**KILKENNY COUNTY COUNCIL**

**Kilkenny Biodiversity & Recreation Countryside Park**

*For consideration by the Elected Members  
of Kilkenny County Council  
at monthly meeting to be held  
on 15<sup>th</sup> March 2021*

**Appendix 2**  
**Senior Planner's Report**

CONCEPT PLAN

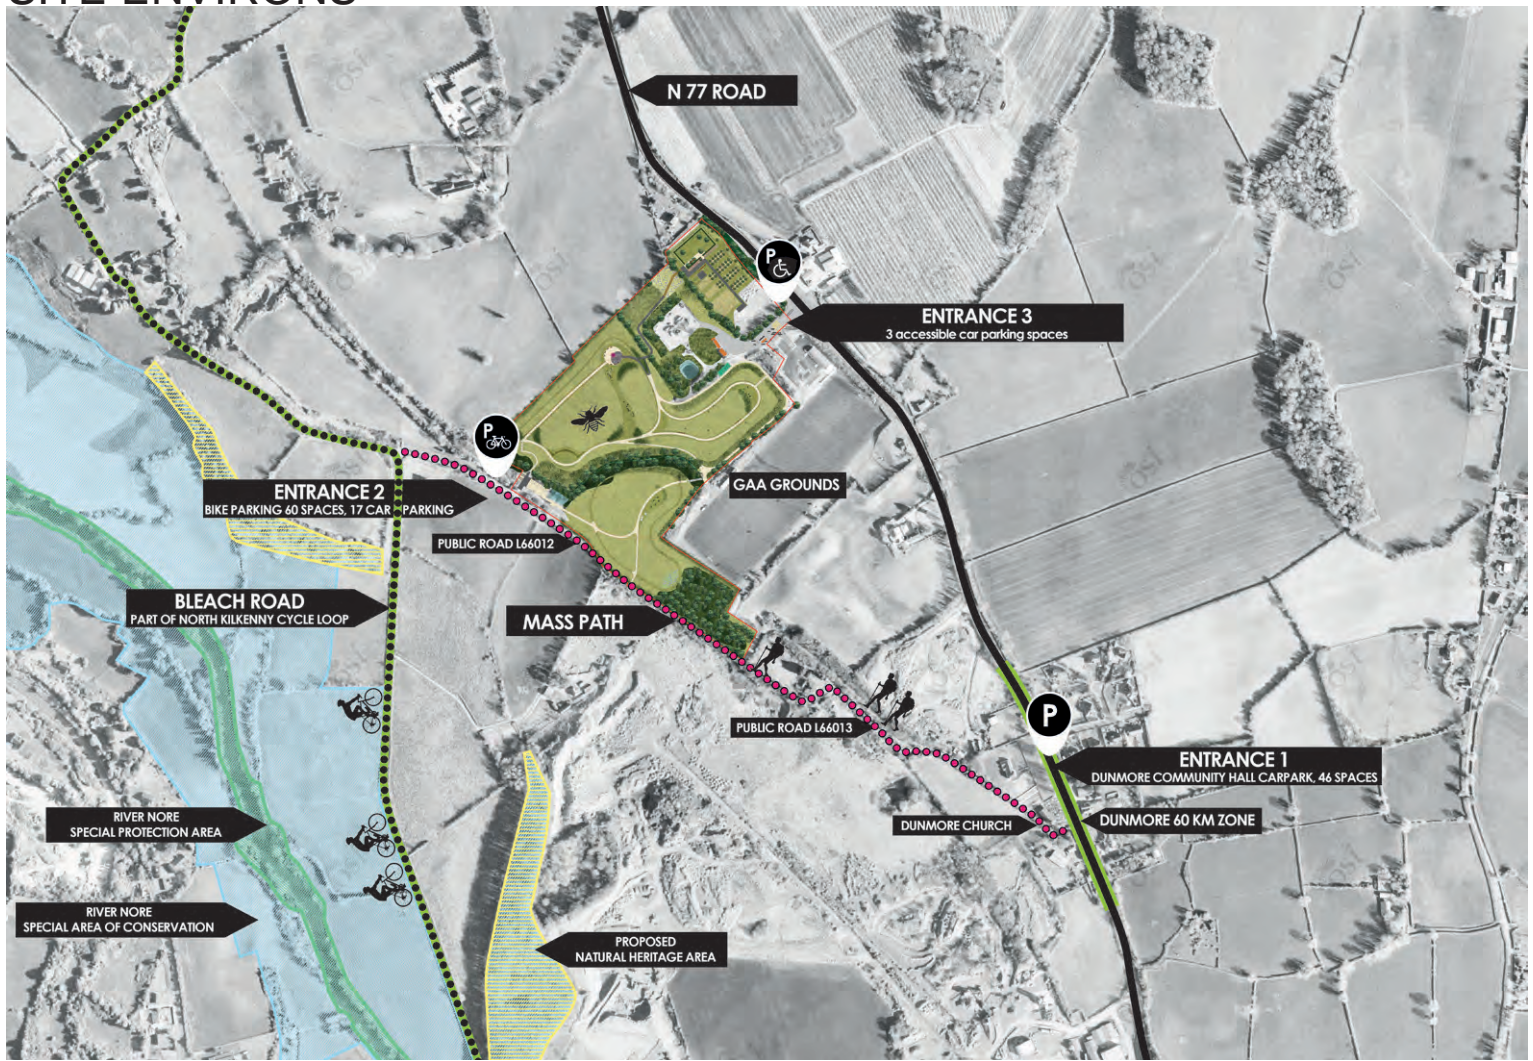
- Revised proposals for access to the site, including reduction from 20 car-parking and one coach space at entrance 3 (existing entrance to the civic amenity site) to three accessible car-parking spaces, as suitable accessibility routes could not accommodate at entrances 1 or 2 due to topographical constraints. The proposal includes for a dedicated Park Warden and signage and clamping for any non-compliance with accessibility only parking in this area.

- The revised Traffic Assessment notes that comparing anticipated usage of the proposed park with Woodstock Gardens, that the reduction from 79 to 62 car parking spaces is deemed appropriate.
